RE: **Permit Tracking No. LU035MN**
American Magnesium, LLC's
Response to MMD Comments Dated May 3, 2019

American Magnesium, LLC (AmMg) has prepared the following responses to technical comments on the amended Plan of Operations (dated April 2019) issued by the Mining and Minerals Division (MMD) on May 3, 2019. MMD's complete comment is provided in italics, followed by AmMg's response in regular text.

Figure 1

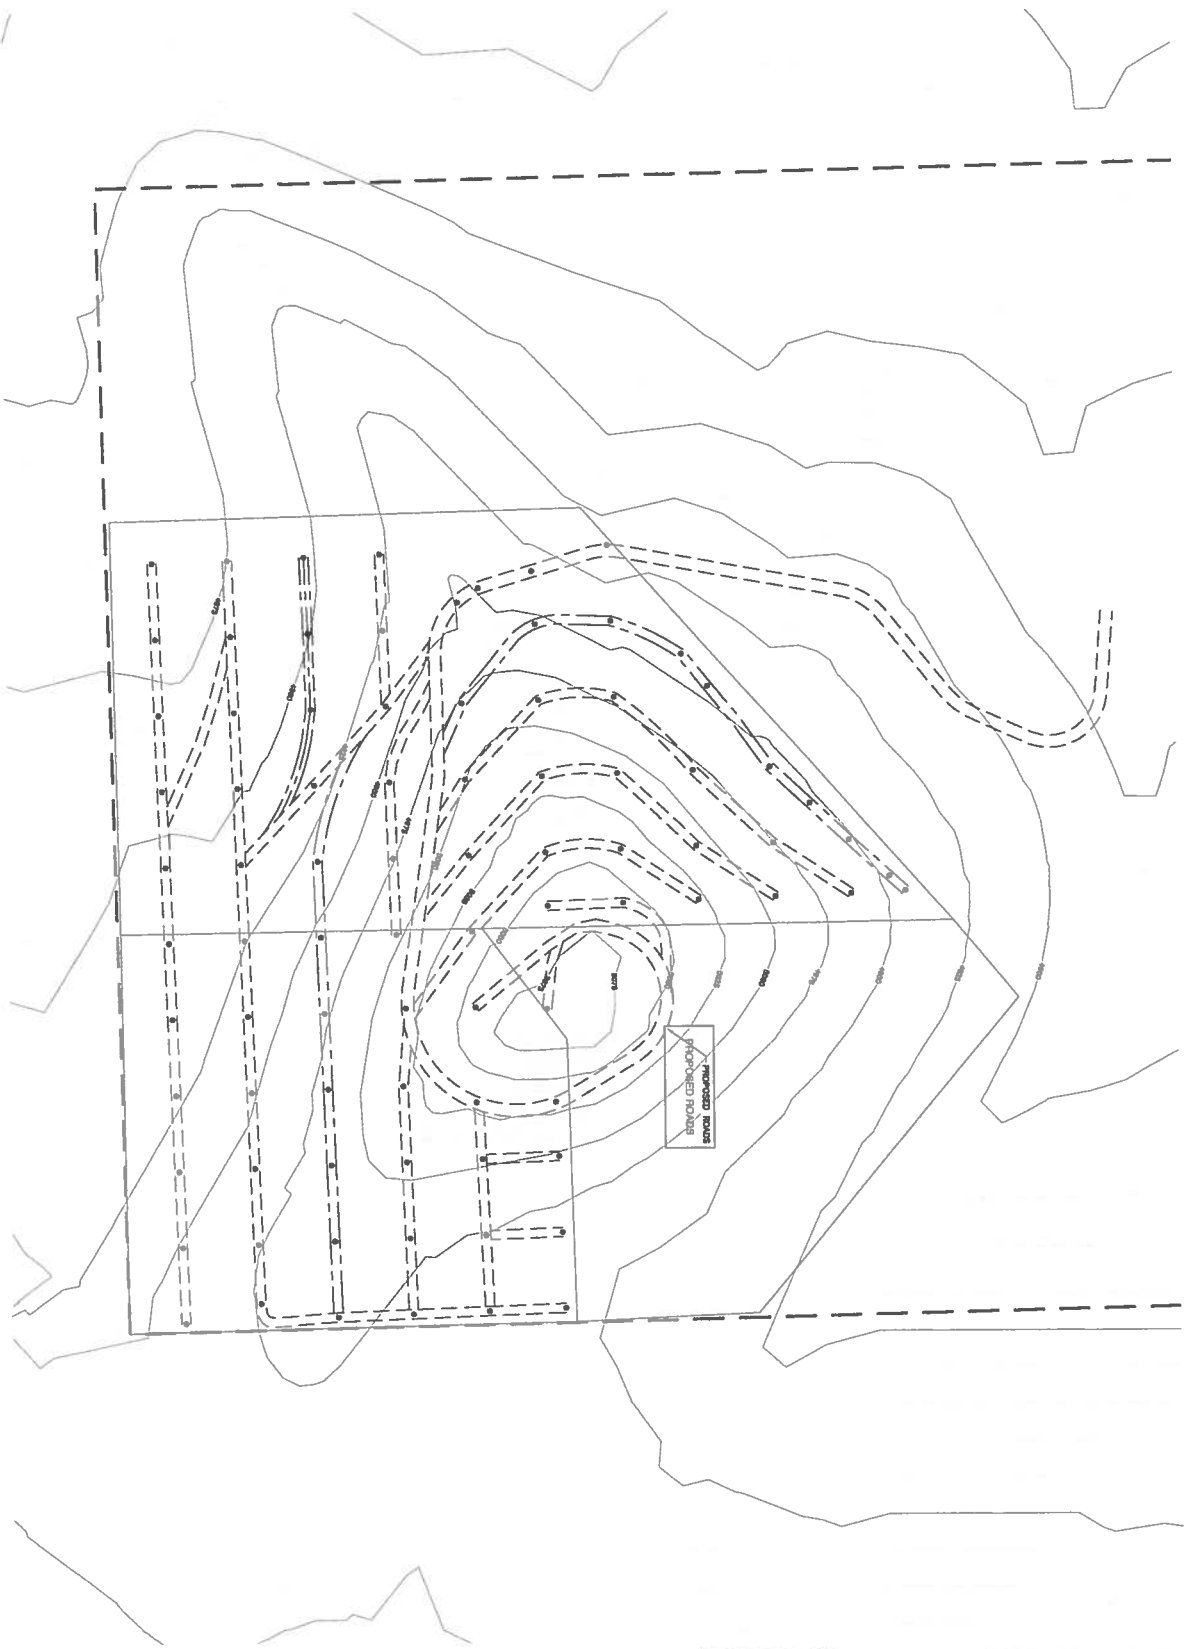
- 1. AmMg's Revision 4 states that exploration drill pads will be 100 square feet and that in steep terrain a "bulldozer will be used to blade a road for the drill rig" where needed.*

Please provide:

- a. a map showing the anticipated locations of the drill pads and dimensions*
- b. a map showing expected roads that will be required for drilling rig access*
- c. an estimate of total acreage to be disturbed from resource verification (exploration)*

Figure 1 is a map showing the proposed locations of the 86 exploratory boreholes in the Phase 1 and 2 mining areas. The map also shows the locations of roads that will be constructed to provide access to the exploratory boreholes. The width of the self-contained, track-mounted drill rigs proposed for use averages approximately 8 feet. Therefore, the access roads will be approximately 12 feet wide. It is anticipated that the exploratory boreholes will be drilled in the centers of the access roads and that individual drill pads will fit within the access roads and not require additional disturbance.

It is anticipated that some exploratory borehole locations will be accessed without constructing a road; however, the assumption made in preparing Figure 1 is that each location will require an access road. Based on this assumption, a total of 10,626 linear feet of access road will be constructed. Assuming an average width of 12 feet, the estimated area that will be disturbed is 127,512 square feet (2.93 acres).
